Section 75W Modification Application Environmental Assessment Report

Central Park, Broadway

Modification to Approved Concept Plan MP06_0171 (Mod 11)

December 2014 ■ 14022

Figure 1 – Proposed envelope modifications (red = current concept plan, white = proposed envelope)

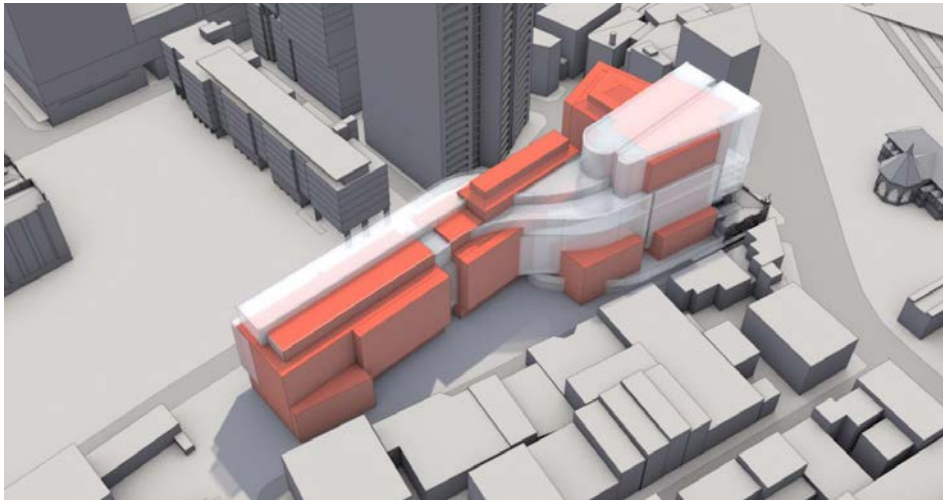
The modification involves modification to the massing of Block 11 primarily to reflect the concurrent Block 11 envelope.

The proposal consolidates the three disparate building forms of the current concept plan (as shown in **Figure 2**) into a single unified and cohesive form, whilst still maintain connectivity and permeability through the site at the ground plane. In addition the proposal:

- significantly expands the publicly accessible landscaped parks on both Wellington and O'Connor Streets by approximately 170% (1940sqm versus 3330sqm) when compared to the existing concept plan.
- optimise solar access into Wellington Street as a result of shifting the western portion of the envelope as far north as possible and stepping the setbacks of the upper floors.
- Use of location and shape to optimise solar access into the O'Connor Street park, whilst minimising overshadowing
- Expansion of the extent of publicly accessible landscape whilst also integrating a new through site link to connect O'Connor and Wellington St pedestrian desire lines.
- Relocation of vehicle access to O'Connor Street only, removing the vehicle access from Wellington Street at the southern end of the site.

Figure 1 below identified the proposed massing variations shown in colour, with red identifying the existing Concept Plan and white indicating the proposed envelope.

Figure 4 – Block 11 – Public Domain Plan – Proposed (Mod 11)
 Source: Foster + Partners

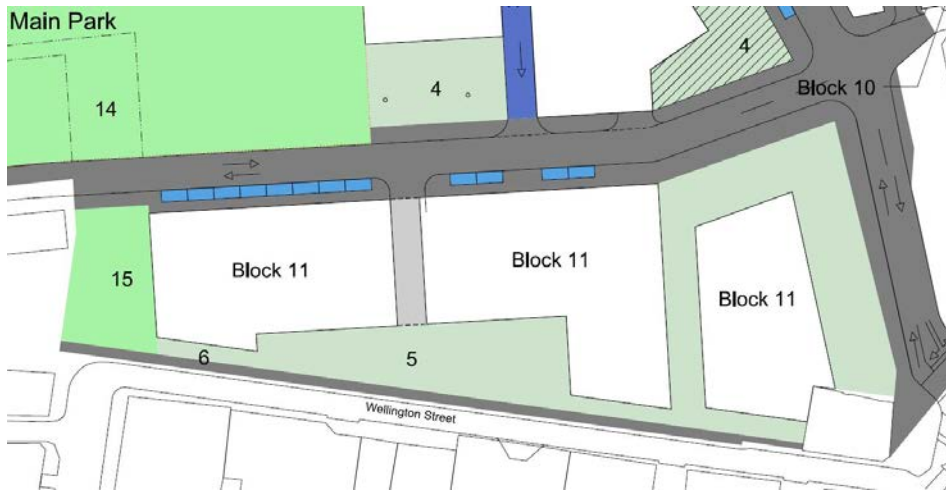
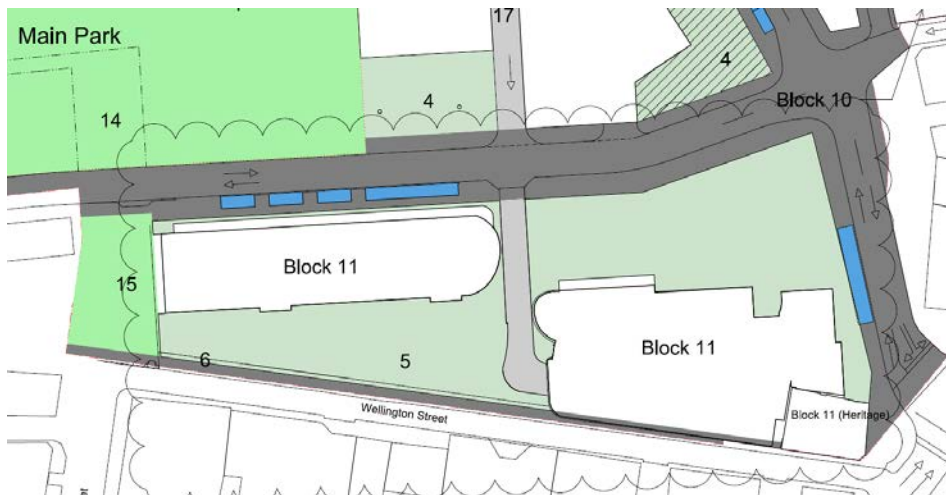
The proposed modification seeks to refine the public domain plan to accurately reflect the concurrent SSD application for Block 11. The modification seeks to amend the footprint of the existing building, and more importantly the distribution of public open space and public domain. As shown below in **Figure 3** and **4**, the proposed modification provides a significant increase in public domain area, largely arising from a reduced building footprint.

This area represents a 170% increase in landscaped open space as proposed under the current Concept Plan. The reallocation of the public open space will be provided in two distinct areas being O'Connor Street Park (2,160m²) and Wellington Street Park (1,170m²).

Furthermore, as shown in **Figure 4**, the proposed modification provide an area of publicly accessible space at the centre of the site (ground floor) which will allows pedestrian access through the site, consistent with present desire lines.

The proposed modification also seeks to amend the on-street parking layout on both O'Connor and Kensington Streets (shown as blue in Figures## and ##). The proposed amendments seek to redistribute the on-street spaces to allow for a revised vehicle entry point to the Block 11 Site (as shown below in Figure ##), and to provide space for vehicle drop off/pick up that will service the proposed Childcare Centre and retail tenancies of Block 11 (included as part of the concurrent SSD). The existing and proposed layout of on-street car parking can be seen in **Figure 3** and **4**.

Figure 7 – Overshadowing Plan – 12pm on June 21 (Mod 9 envelope shown outlined in red)
 Source: Foster + Partners

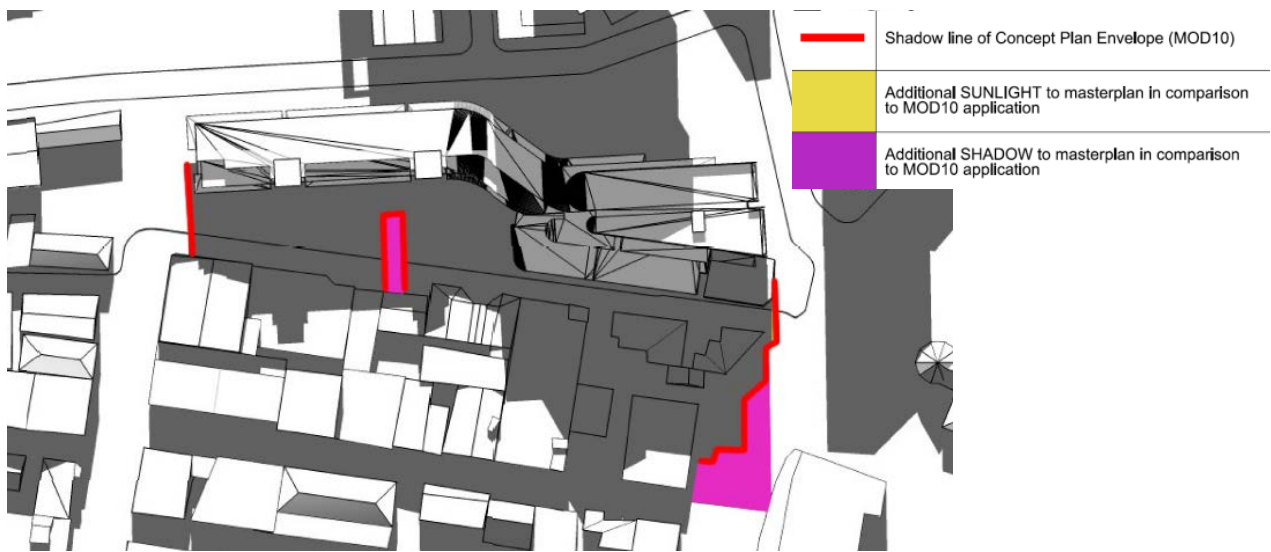
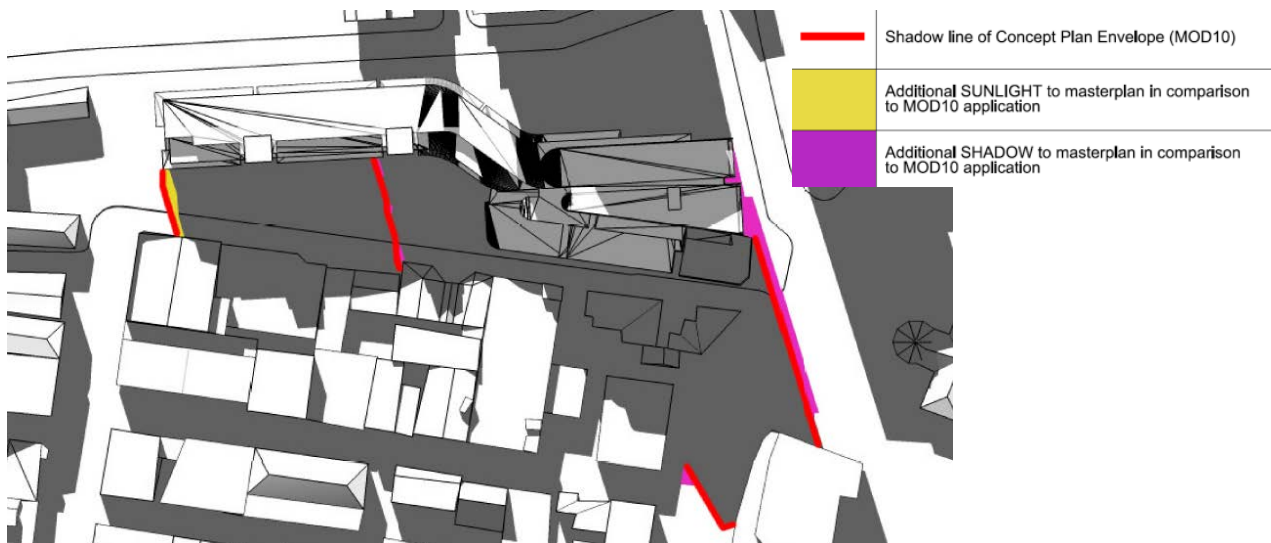
Shadow diagrams of the proposed Block 11 envelope are provided in **Figure 7** and **8** (selected) and **Appendix A** illustrate the effects of the proposed modification on the residential dwelling and non-residential uses south of site on Wellington Street.

- The building mass has been shifted north, further away from Wellington Street
- Given the removal of the 'slots' which exist in the current concept plan envelop, overshadowing will occur at midday in mid-winter for a short period of time.
- Whilst the building height has been increased, due to the separation distance and angle of the sun, increased levels of solar access are achieved to Wellington Street.
- Due to the orientation of the site and Wellington Street buildings, there is no change to the shadow impact between the existing concept plan and proposal.
- Minor additional overshadowing will occur in the early morning (9am in mid-winter) to the rooftops of Wellington and Queen Street buildings (this is shown above in **Figure 7** and **8**).
